City Of Vallejo Architectural Heritage and Landmarks Commission REGULAR MEETING – 6:30 P.M.

January 17, 2019

- A. **602 Georgia Street** – Certificate of Appropriateness #18-0018; a request to renovate an existing single-family residence and construct an addition of approximately 450 square feet.

**STAFF REPORT – PLANNING
CITY OF VALLEJO
ARCHITECTURAL HERITAGE AND LANDMARKS COMMISSION**

1 Existing Site Plan
 A1.1 1/16" = 1'-0"

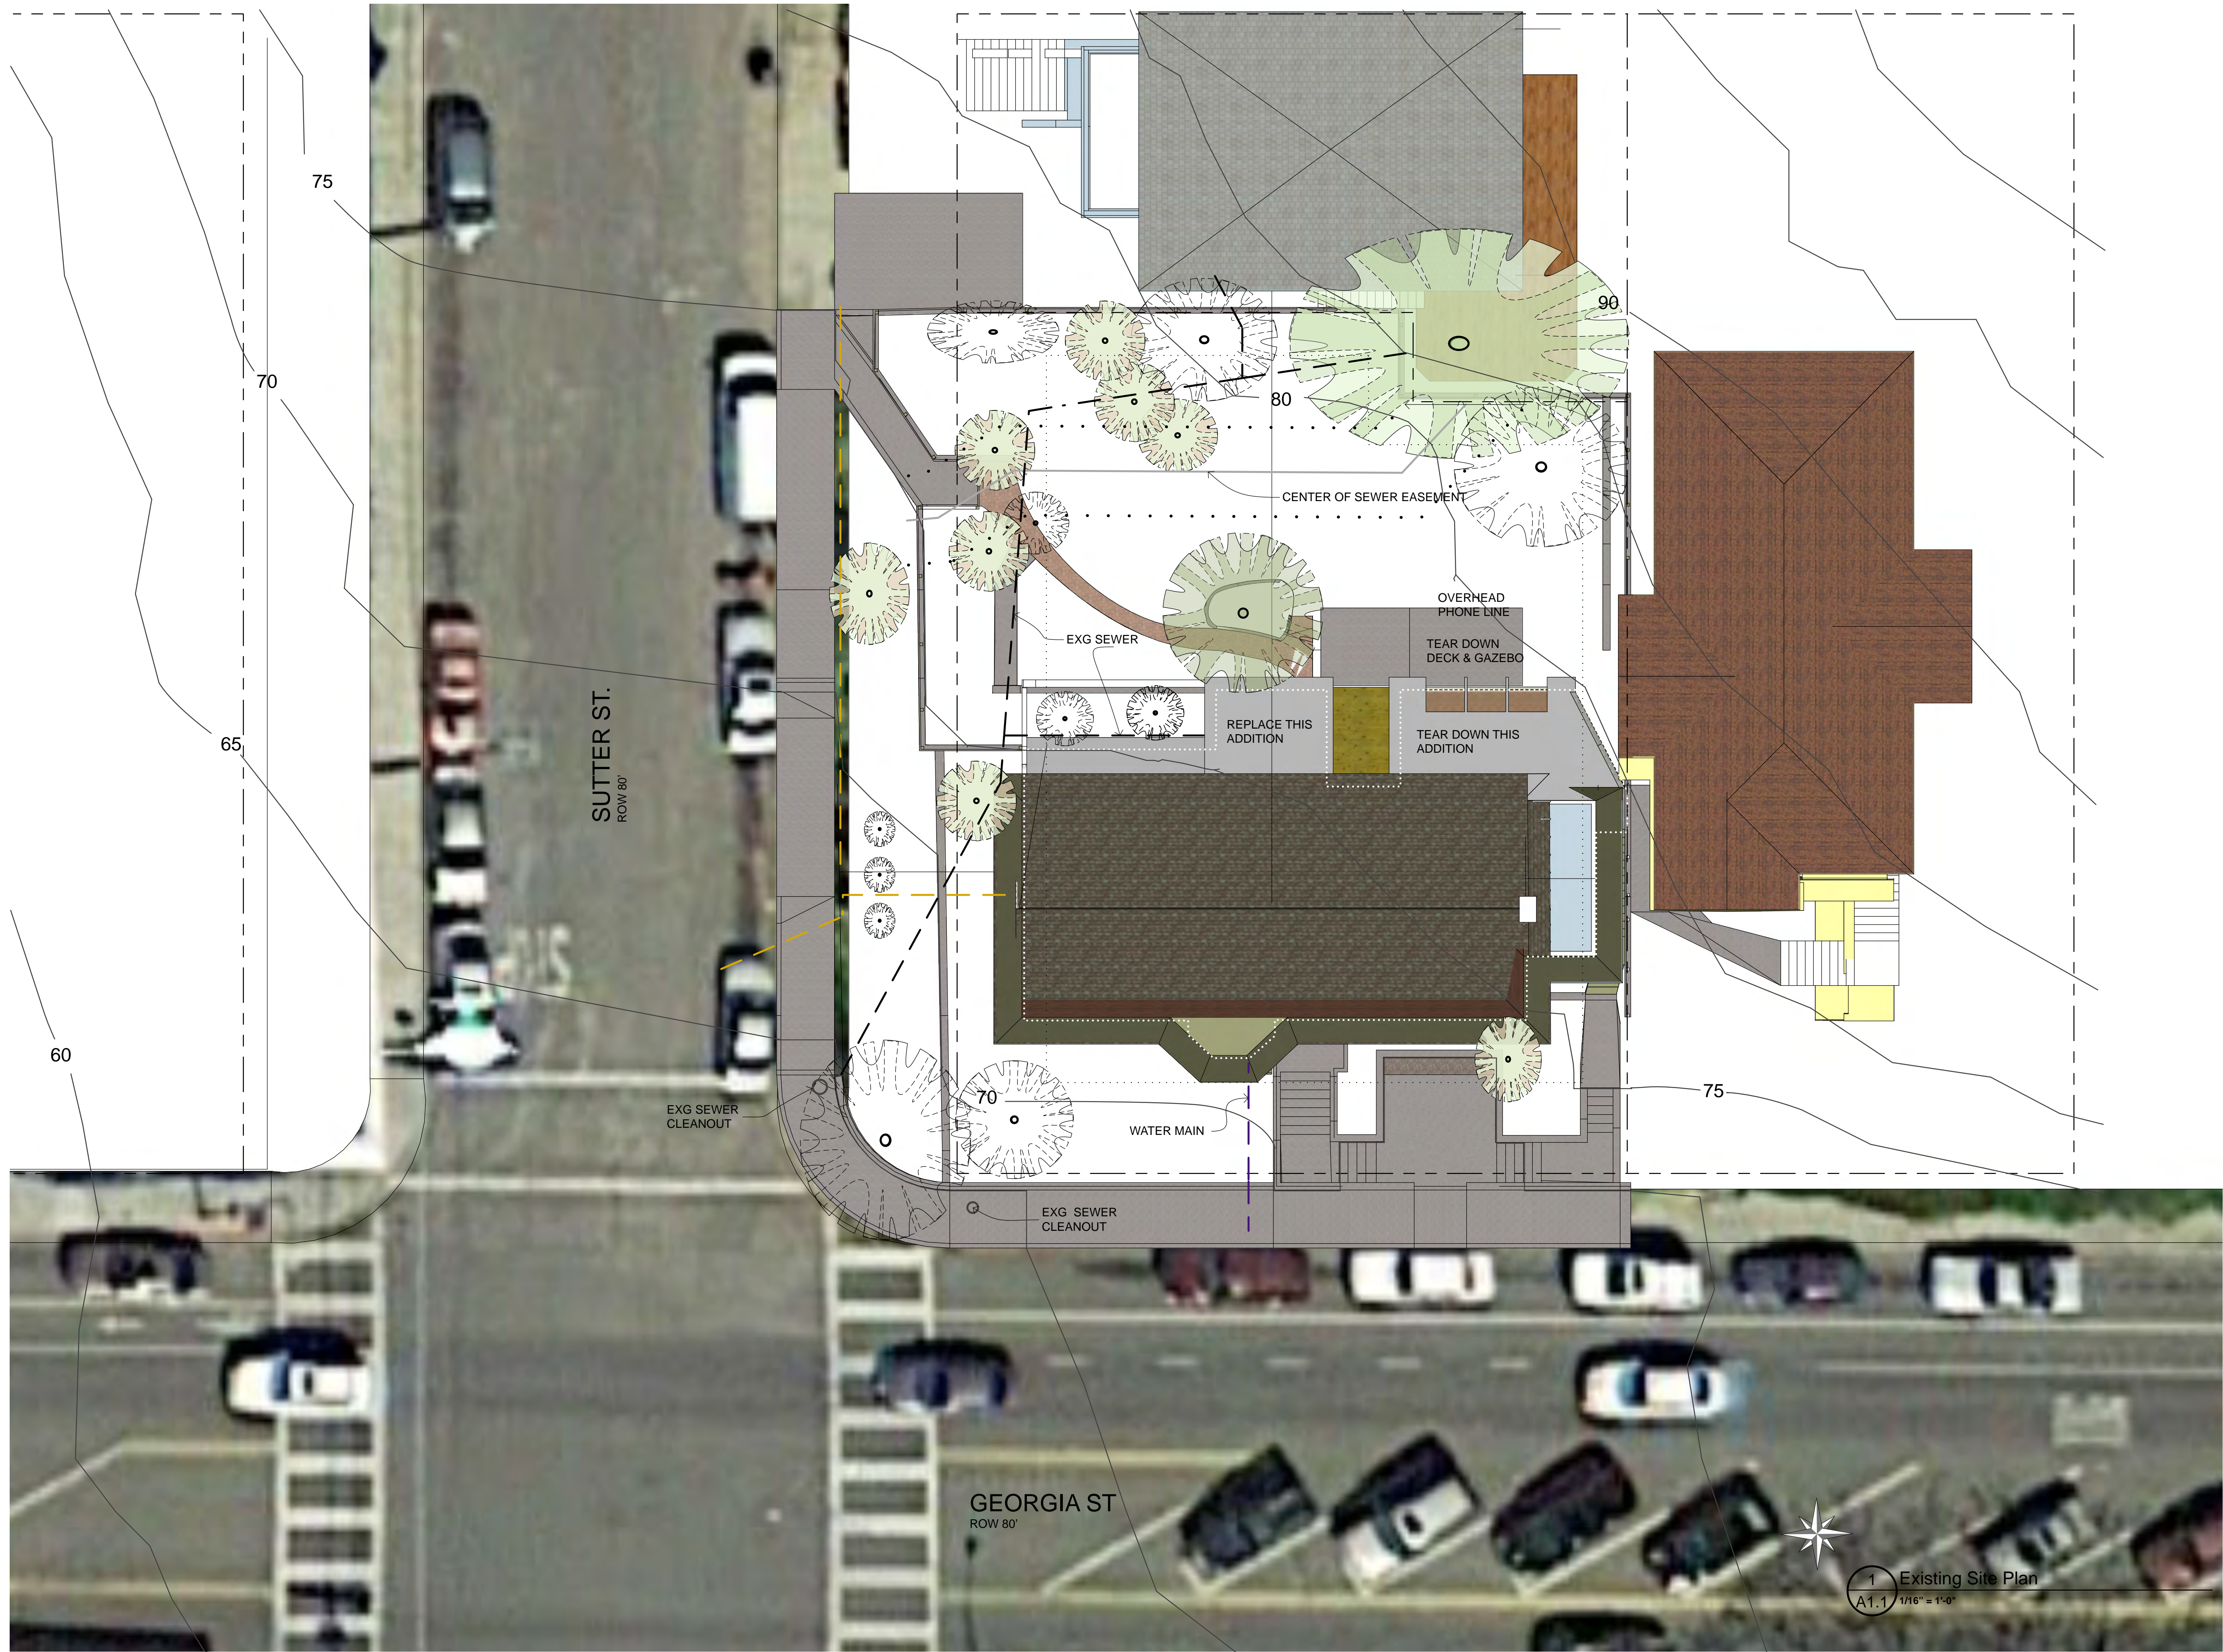
1. Removal of a one-story sunroom, removal of a deck and gazebo and removal of a one story breakfast nook, see sheet A1.1 of the attached plans.
2. New two-story addition on the northwest side, and new patio.
3. Expansion of existing basement to accommodate a new 700 square foot, three car garage with a workshop. The northern portion beneath the two-story addition is outside of the existing building footprint and is subject to AHLC approval.

A7.1

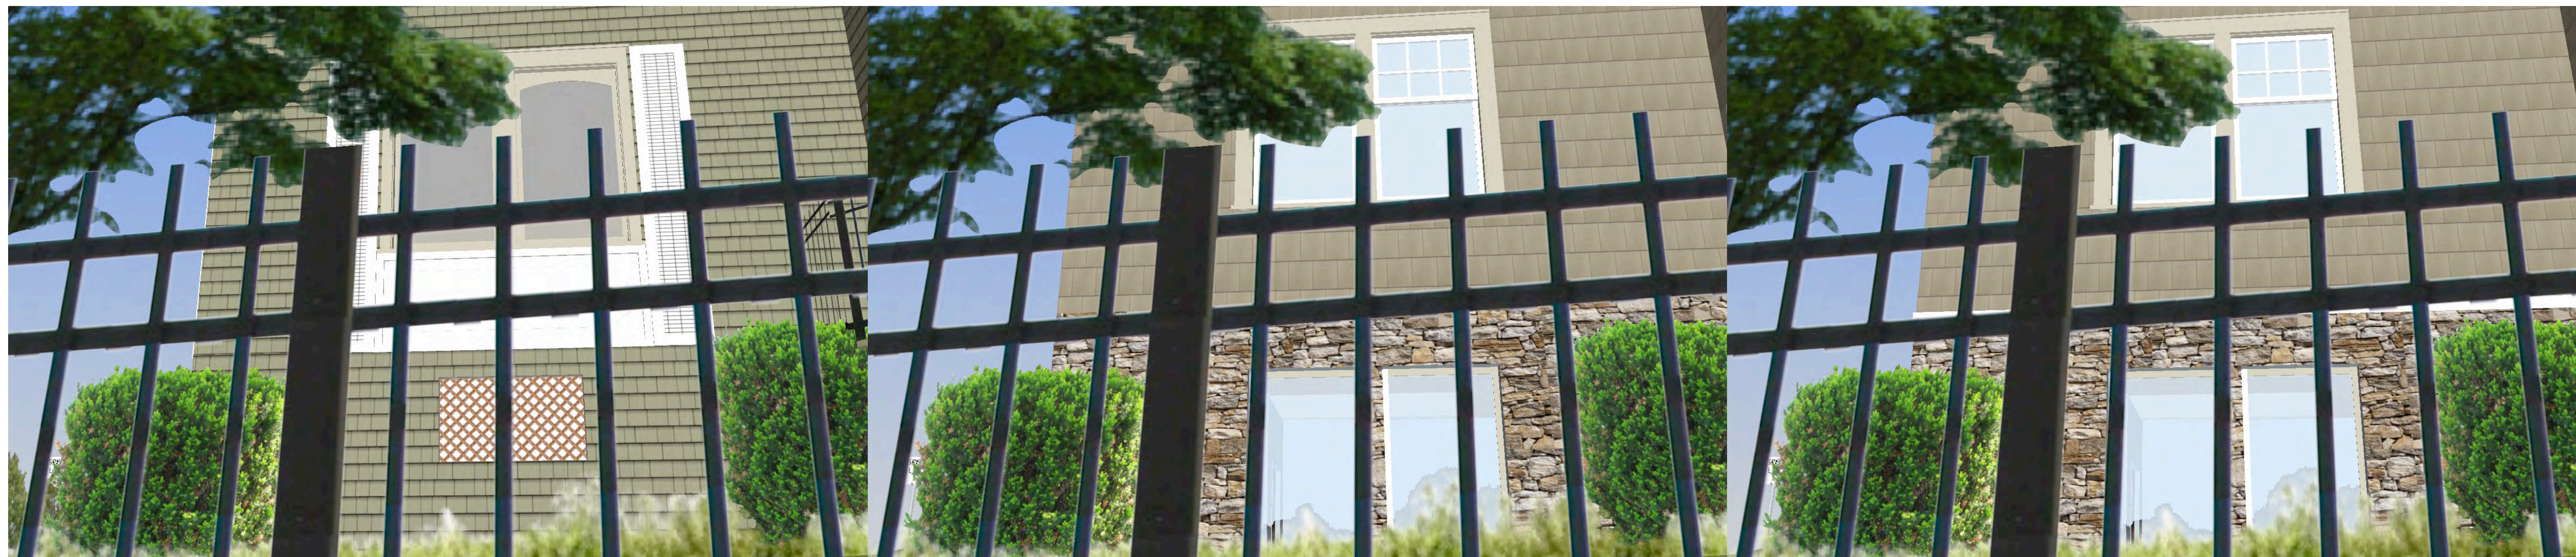
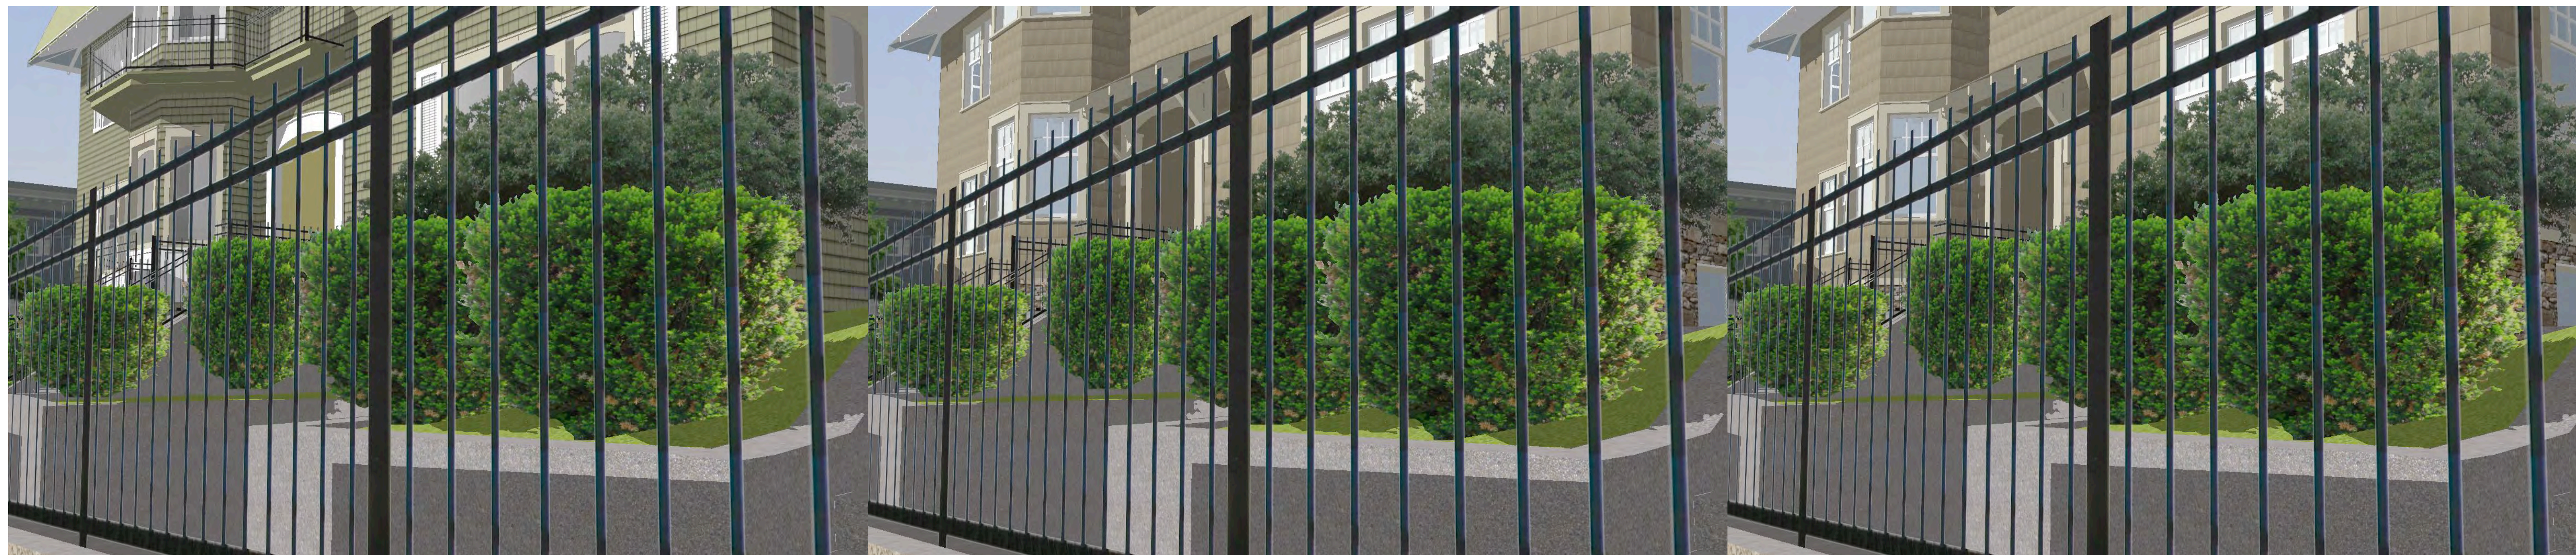
- **Addition West Window:** The west wall of the north addition is a relatively large (approximately 7.5 feet by 19 feet) expanse that is devoid of windows, or significant articulation or detail. Staff is recommending that an additional window be provided on this wall. *See top right image on A7.1, bottom right image on A7.2, and top right image on A7.3.*

- **Basement Stone Cap:** Staff suggested that the applicant provide a protruding course of flat stone work over the proposed stone cladding, to help provide a more elegant and finished transition between the stone and the shingles. The applicant has rendered a horizontal band of white trim (wood or substitute) for AHLC's consideration. *See bottom right image on A7.1, top right image on A7.2, and right hand images on A7.3.*

1. Add a gable roof over the north addition.
2. Provide an additional setback on the west side of the north addition.
3. Add a cap to the stone veneer at the basement level.
4. Add simulated divided lights on the basement windows.
